DEVELOPMENT REVIEW COMMITTEE (DRC) COMMENT REPORT

PROJECT NAME: Genco Cluster

CASE NUMBER: R18010

REQUEST: Site Plan Level III Review: 3 Residential Cluster Units

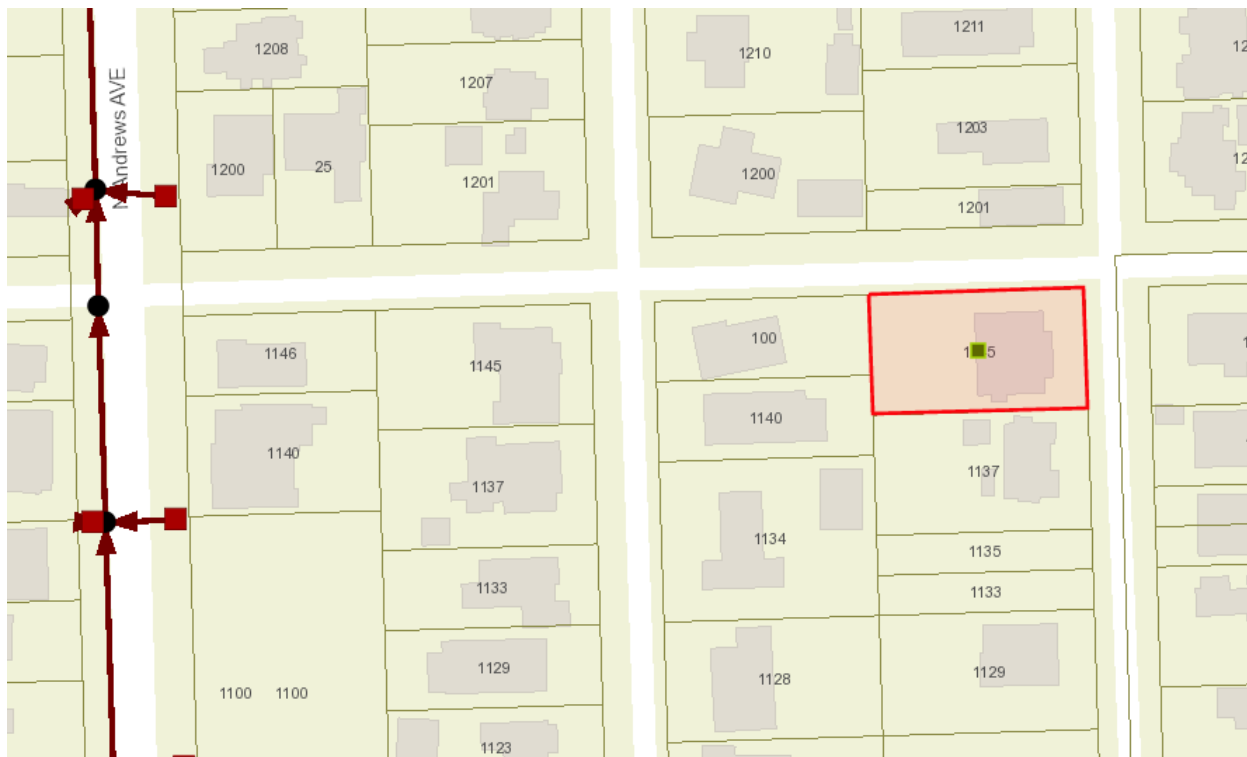
The City GIS shows grass swales as stormwater assets adjacent to the proposed development-- as shown in the map provided at the end of this report. The following comments pertain to possible impacts of the proposed development and/or construction activities to the existing condition of the City's stormwater assets. The applicant shall provide an itemized response letter addressing the following comments:

1. Consider changing proposed parallel street parking surface from asphalt to pervious pavers.
2. Provide water quality treatment for the removed street grass swale area of NE 12 Street

1. Please provide (or revise if already submitted) an erosion, sedimentation, and stormwater pollution prevention plan (**SWPPP**) showing the adjacent City's existing stormwater system as shown in the survey and to the limits shown with green line work in the storm map provided at the end of this report. A copy of the approved SWPP shall be at the construction site from the date of demolition initiation to the date of final construction activities.

- a) Contractor shall provide CCTV videotapes to City STW OPS of the existing stormwater system to the limits shown with green line work in the storm map provided at the end of this report in order to document the PRE and POST construction conditions of the City's storm system.
